Aeronautical Study No.  
 2020-AWP-7967-OE

**\*\* DETERMINATION OF NO HAZARD TO AIR NAVIGATION \*\***

Structure: Building Scripps Mercy Replacement Hospital T1  
 Location: San Diego, CA  
 Latitude: 32-45-03.93N NAD 83  
 Longitude: 117-09-37.19W  
 Heights: 243 feet site elevation (SE)  
 254 feet above ground level (AGL)  
 497 feet above mean sea level (AMSL)

#### 6. BASIS FOR DECISION

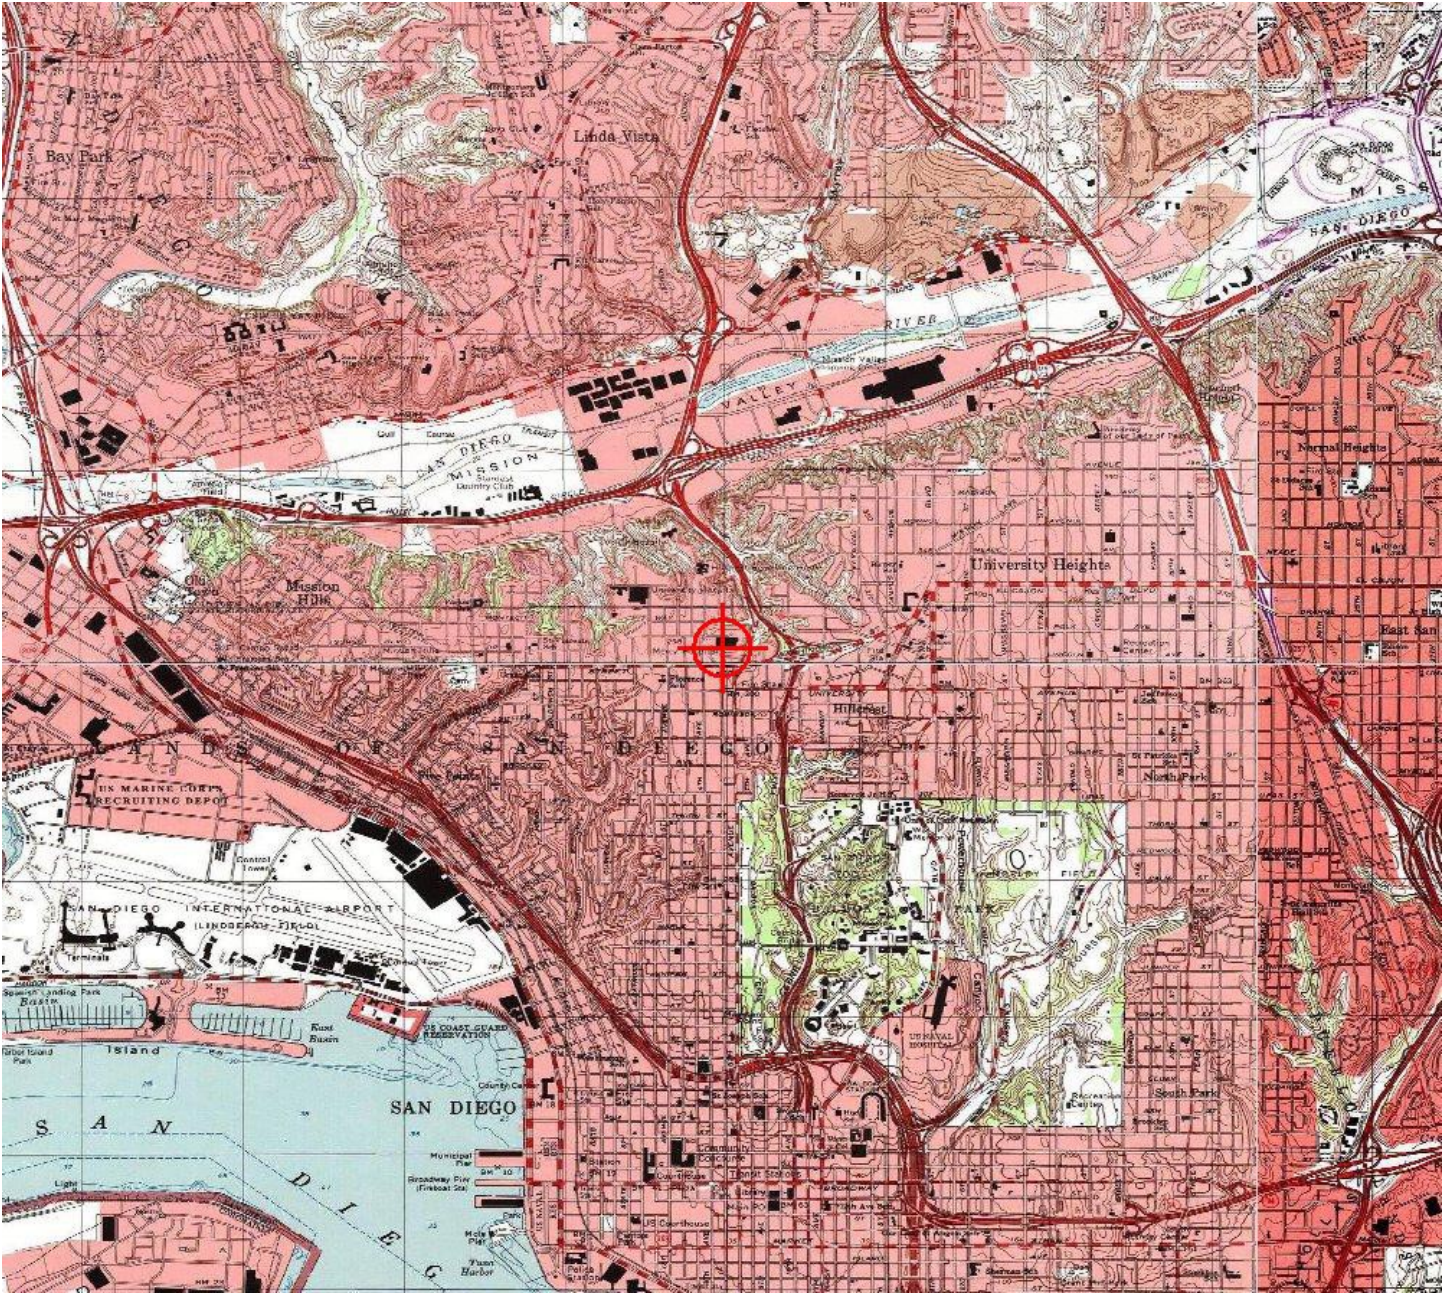
The proposed building would exceed the SAN horizontal by the values listed above, however, there are no IFR effects to any arrival or departure procedure. Even though the proposed structure would exceed the VFR conical surface by the values shown above; the terrain at this location also exceeds the horizontal surface by 77 feet. FAA Order JO 7400.2M, Procedures for Handling Airspace Matters, allows for traffic pattern airspace penetration exception on a case-by-case basis where the terrain is significantly higher than the airport elevation. This case falls within that exception, the difference between the airport elevation and the rising terrain is approximately 77 feet. In addition the VFR Traffic Pattern Airspace surface is already impacted by other structures that are closer to the airport and in close proximity to the proposed building. FAA Flight Standards Division concurred with the proposal. The incorporation of marking and lighting will provide additional conspicuity for VFR and IFR pilots flying in this vicinity of SAN airport.

The structure shall be lighted as outlined in Chapters 4, 5(Red) & 15 of the Advisory Circular AC 70/7460-1M. The advisory circular is available online at [https://www.faa.gov/regulations\\_policies/advisory\\_circulars/index.cfm/go/document.information/documentID/1030047](https://www.faa.gov/regulations_policies/advisory_circulars/index.cfm/go/document.information/documentID/1030047)

#### 6. BASIS FOR DECISION

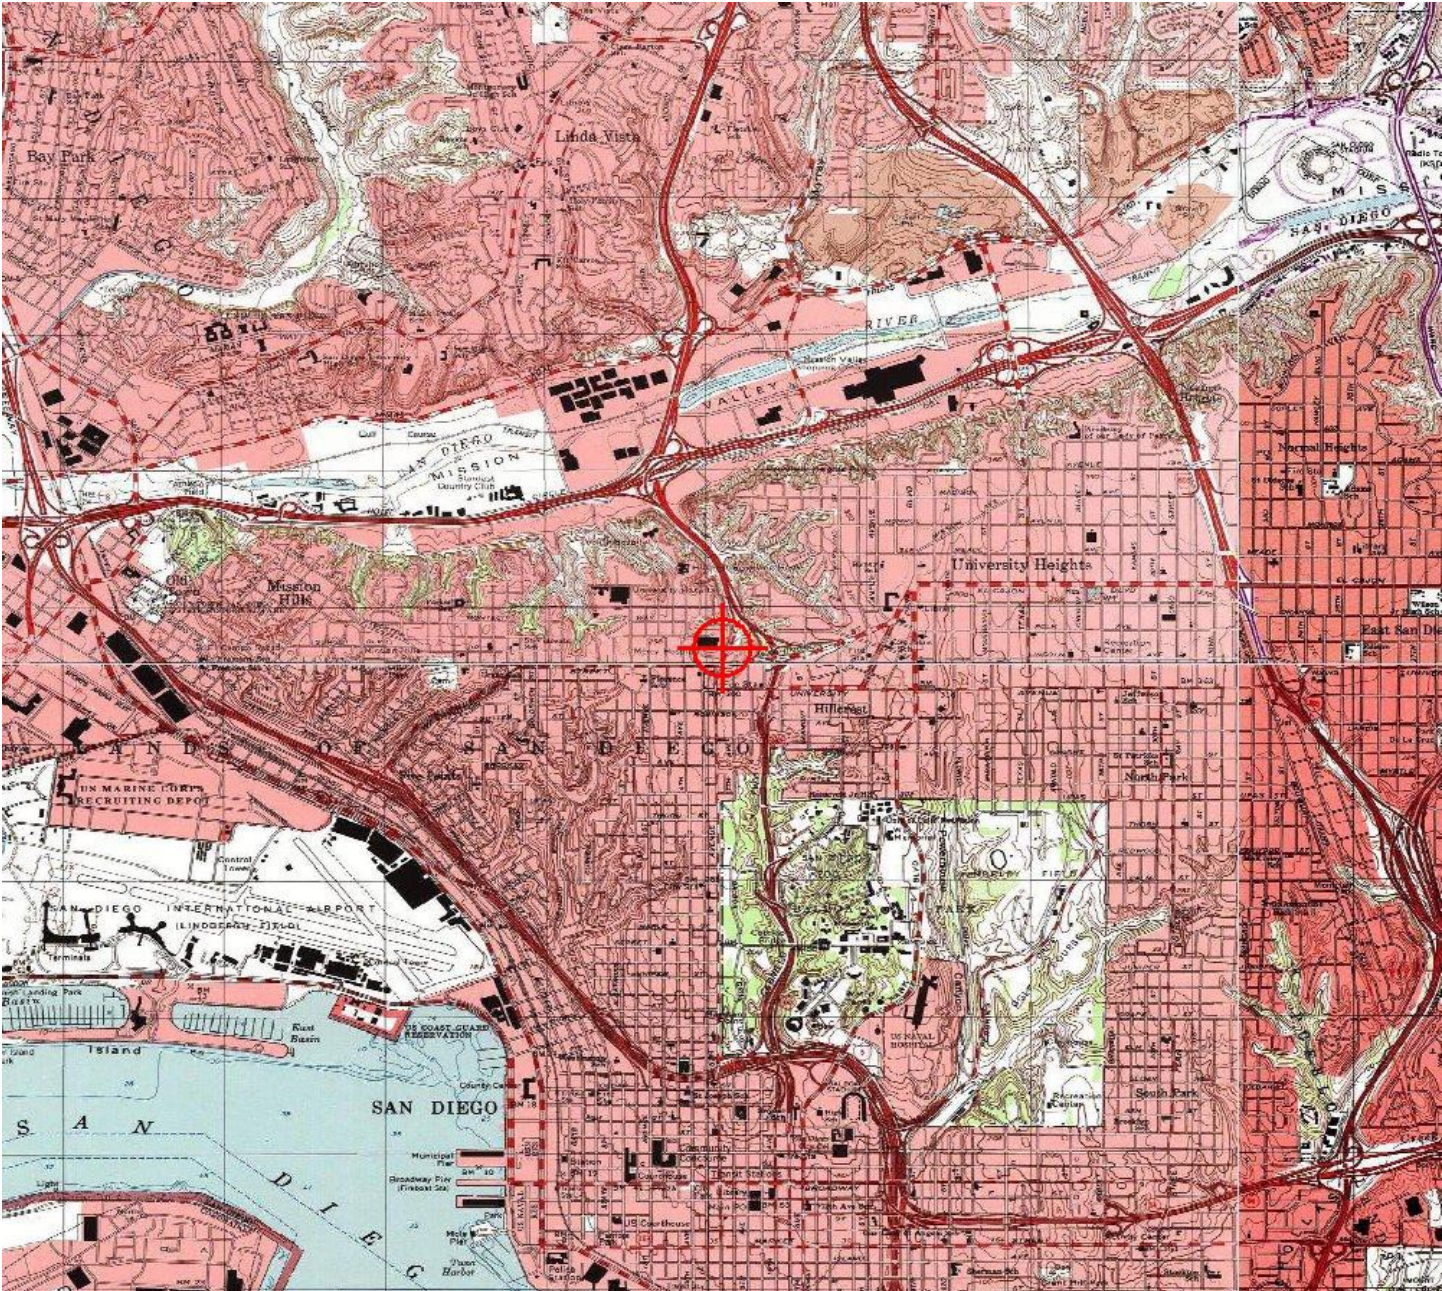
The proposed building would exceed the SAN horizontal by the values listed above, however, there are no IFR effects to any arrival or departure procedure. Even though the proposed structure would exceed the VFR conical surface by the values shown above; the terrain at this location also exceeds the horizontal surface by 77 feet. FAA Order JO 7400.2M, Procedures for Handling Airspace Matters, allows for traffic pattern airspace penetration exception on a case-by-case basis where the terrain is significantly higher than the airport elevation. This case falls within that exception, the difference between the airport elevation and the rising terrain is approximately 77 feet. In addition the VFR Traffic Pattern Airspace surface is already impacted by other structures that are closer to the airport and in close proximity to the proposed building. FAA Flight Standards Division concurred with the proposal. The incorporation of marking and lighting will provide additional conspicuity for VFR and IFR pilots flying in this vicinity of SAN airport.

The structure shall be lighted as outlined in Chapters 4, 5(Red) & 15 of the Advisory Circular AC 70/7460-1M. The advisory circular is available online at [https://www.faa.gov/regulations\\_policies/advisory\\_circulars/index.cfm/go/document.information/documentID/1030047](https://www.faa.gov/regulations_policies/advisory_circulars/index.cfm/go/document.information/documentID/1030047)

#### 6. BASIS FOR DECISION

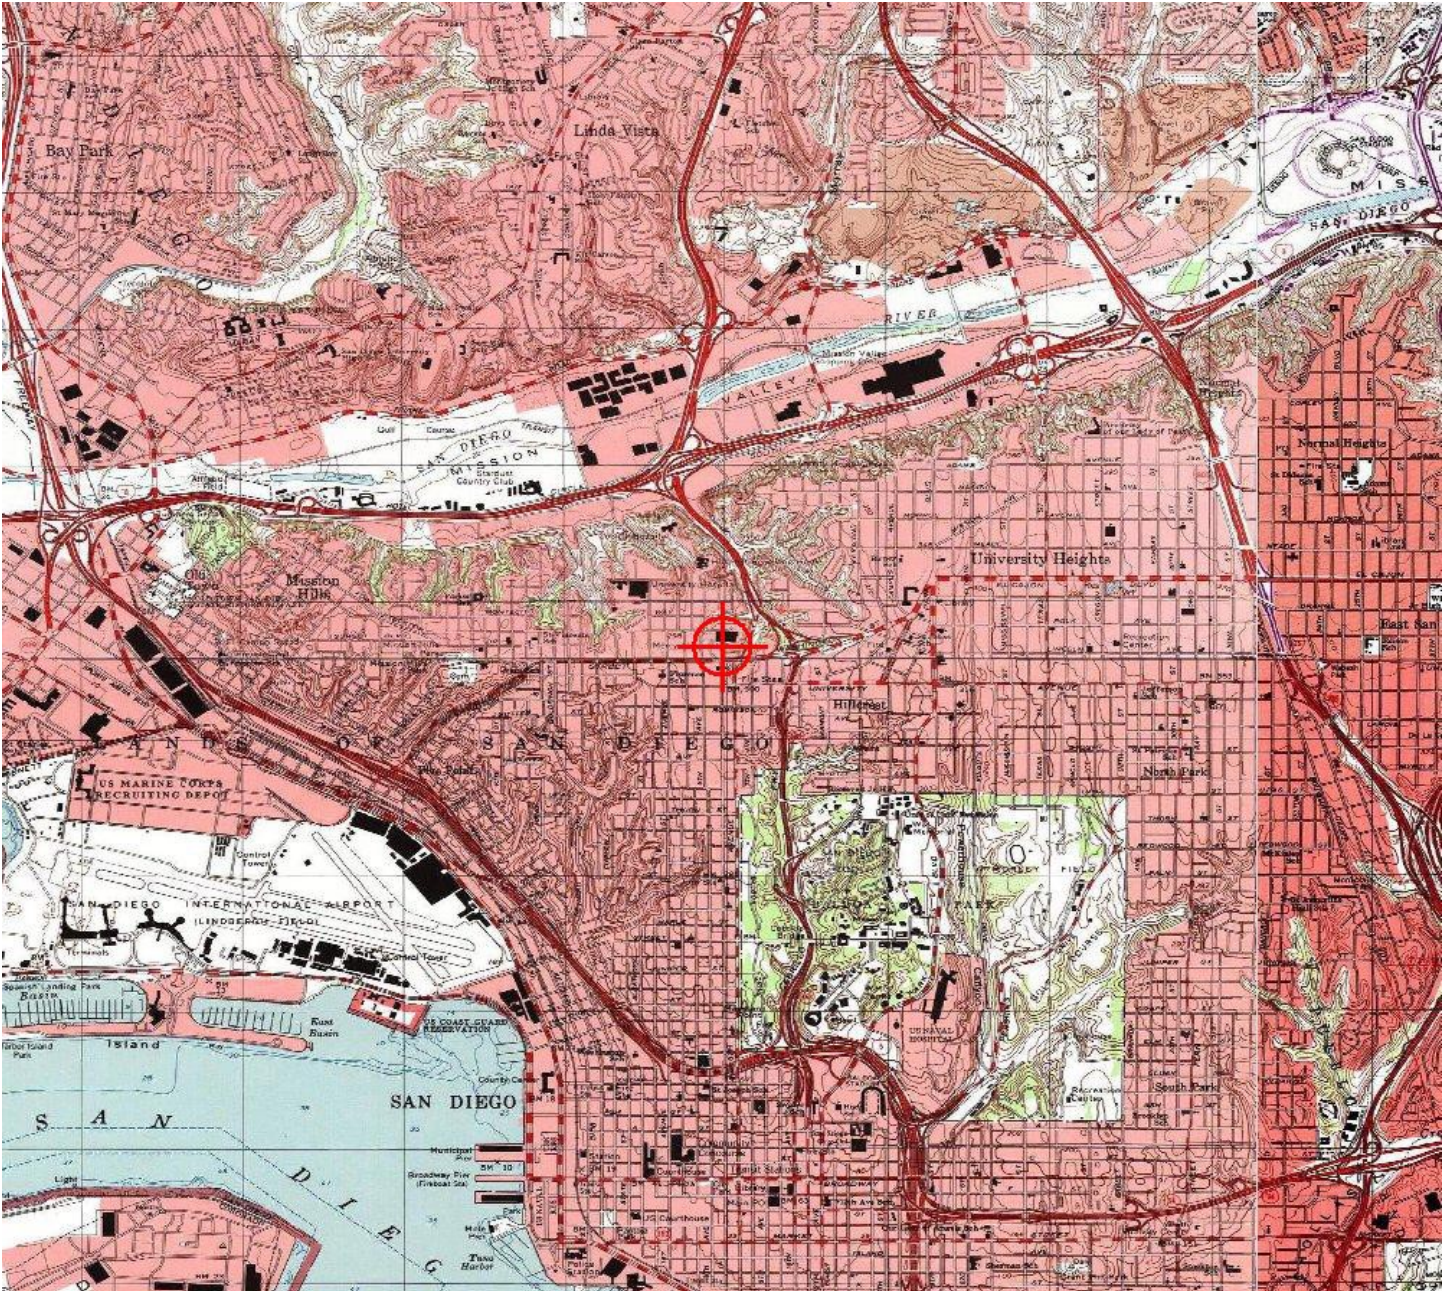
The proposed building would exceed the SAN horizontal by the values listed above, however, there are no IFR effects to any arrival or departure procedure. Even though the proposed structure would exceed the VFR conical surface by the values shown above; the terrain at this location also exceeds the horizontal surface by 77 feet. FAA Order JO 7400.2M, Procedures for Handling Airspace Matters, allows for traffic pattern airspace penetration exception on a case-by-case basis where the terrain is significantly higher than the airport elevation. This case falls within that exception, the difference between the airport elevation and the rising terrain is approximately 77 feet. In addition the VFR Traffic Pattern Airspace surface is already impacted by other structures that are closer to the airport and in close proximity to the proposed building. FAA Flight Standards Division concurred with the proposal. The incorporation of marking and lighting will provide additional conspicuity for VFR and IFR pilots flying in this vicinity of SAN airport.

#### 6. BASIS FOR DECISION

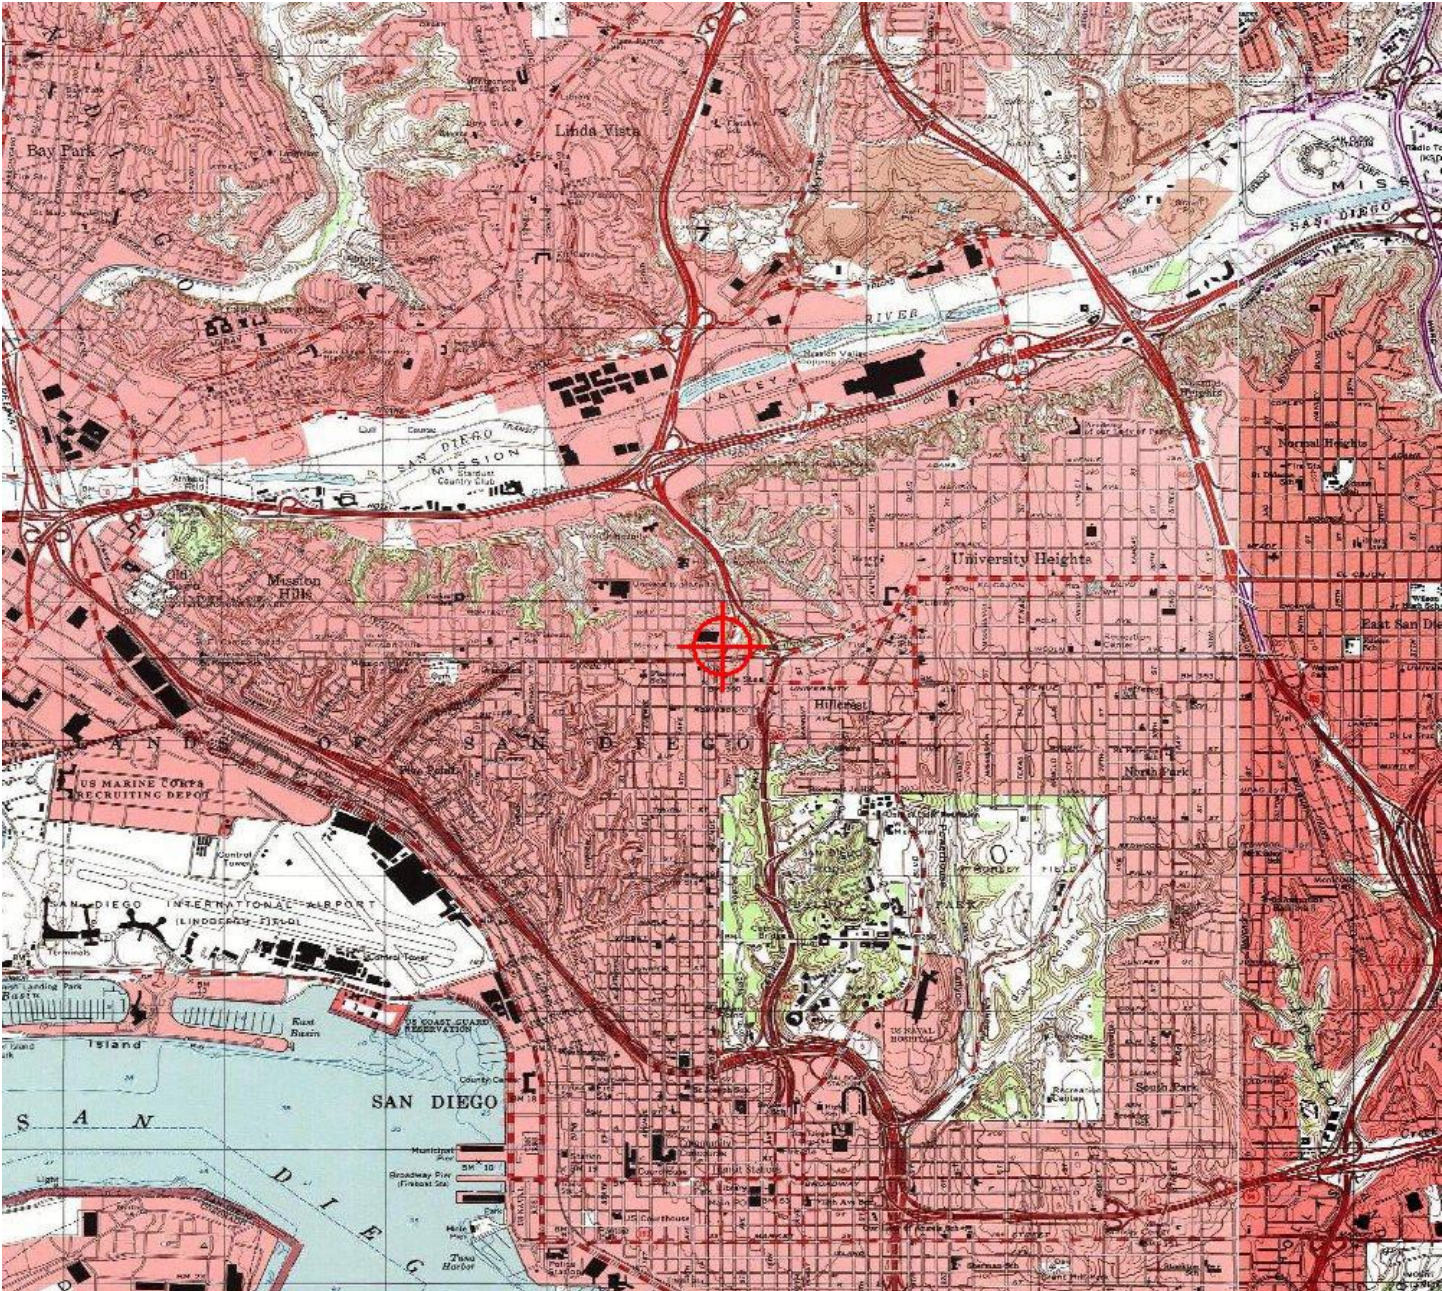
The proposed building would exceed the SAN horizontal by the values listed above, however, there are no IFR effects to any arrival or departure procedure. Even though the proposed structure would exceed the VFR conical surface by the values shown above; the terrain at this location also exceeds the horizontal surface by 77 feet. FAA Order JO 7400.2M, Procedures for Handling Airspace Matters, allows for traffic pattern airspace penetration exception on a case-by-case basis where the terrain is significantly higher than the airport elevation. This case falls within that exception, the difference between the airport elevation and the rising terrain is approximately 77 feet. In addition the VFR Traffic Pattern Airspace surface is already impacted by other structures that are closer to the airport and in close proximity to the proposed building. FAA Flight Standards Division concurred with the proposal. The incorporation of marking and lighting will provide additional conspicuity for VFR and IFR pilots flying in this vicinity of SAN airport.

#### 6. BASIS FOR DECISION

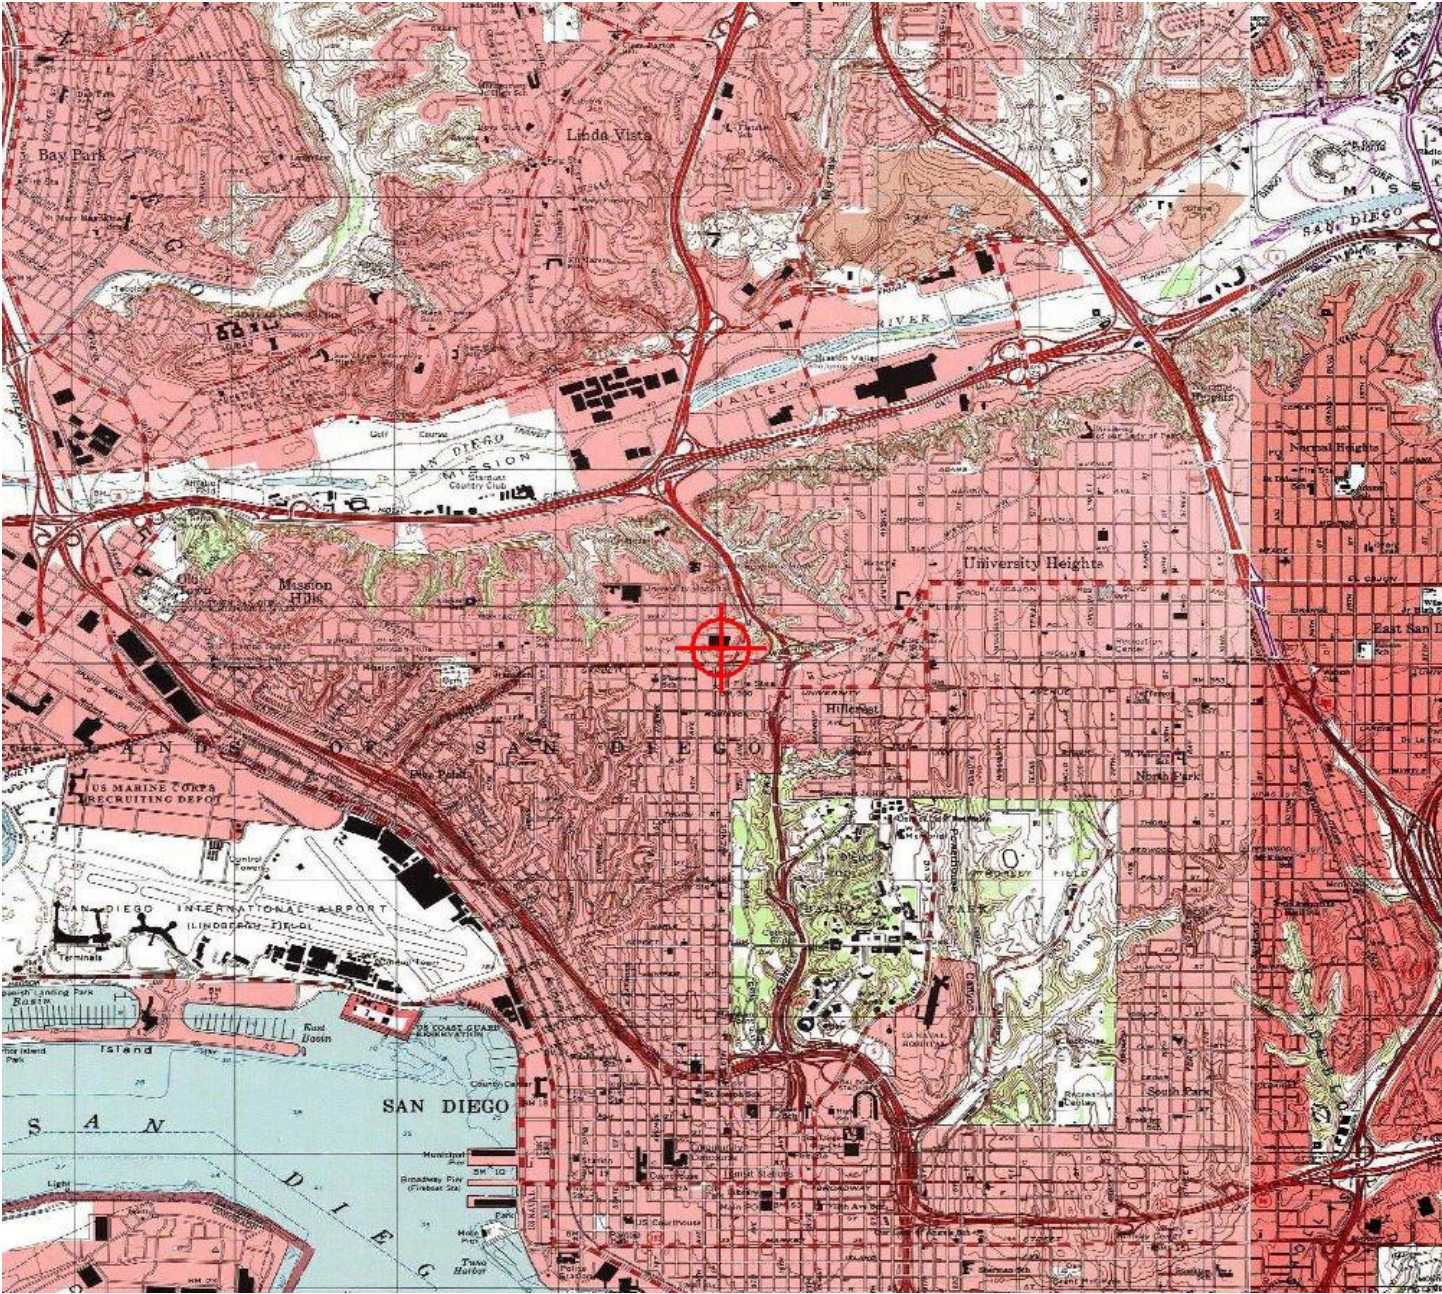
The proposed building would exceed the SAN horizontal by the values listed above, however, there are no IFR effects to any arrival or departure procedure. Even though the proposed structure would exceed the VFR conical surface by the values shown above; the terrain at this location also exceeds the horizontal surface by 77 feet. FAA Order JO 7400.2M, Procedures for Handling Airspace Matters, allows for traffic pattern airspace penetration exception on a case-by-case basis where the terrain is significantly higher than the airport elevation. This case falls within that exception, the difference between the airport elevation and the rising terrain is approximately 77 feet. In addition the VFR Traffic Pattern Airspace surface is already impacted by other structures that are closer to the airport and in close proximity to the proposed building. FAA Flight Standards Division and the US Navy concurred with the proposal. The incorporation of marking and lighting will provide additional conspicuity for VFR and IFR pilots flying in this vicinity of SAN airport.
